PLAT  
THE RIDGE, PHASE TWO, SECTION 1  
BELL COUNTY

THE RIDGE, PHASE TWO, SECTION 1

## Texas Veterans Land Board Survey Requirements Checklist

General tract description Lot 19, THE RIDGE, PHASE 2, SECTION 2, BELL County, VLB Account No. 215783

FINAL PLAT OF

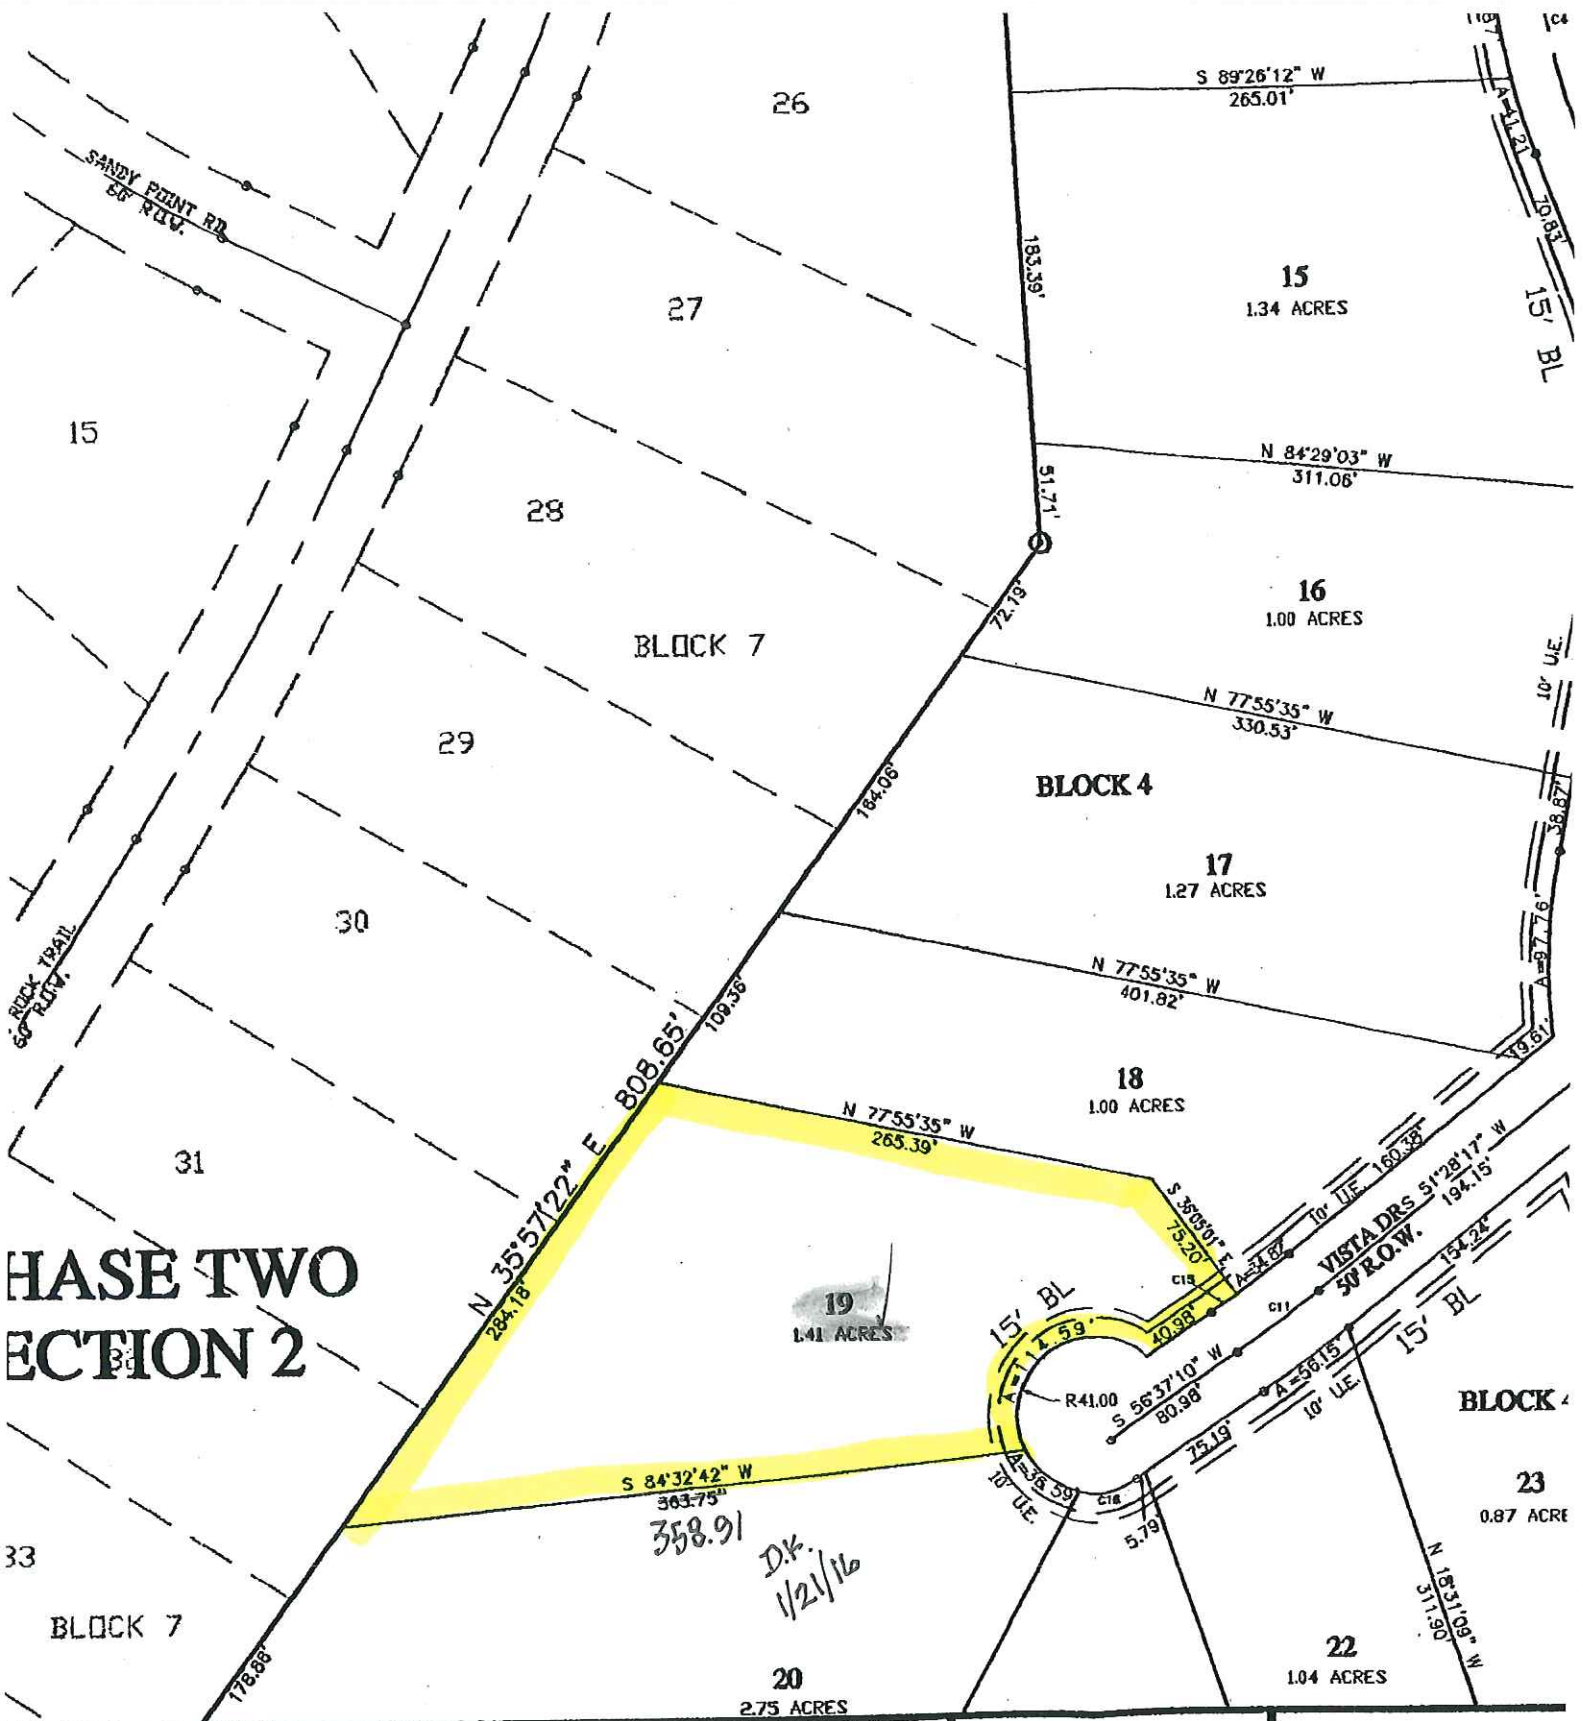
*Plat*  
FMS Correct For 1.41 Acres

Tract 1: 1.4103 Acres (61435 Sq. Feet), Closure: s17.3309e 0.01 ft. (1/121234), Perimeter=1156 ft.

- ☒ The adjusted mathematical closure of any survey shall be no less than 1:10,000.
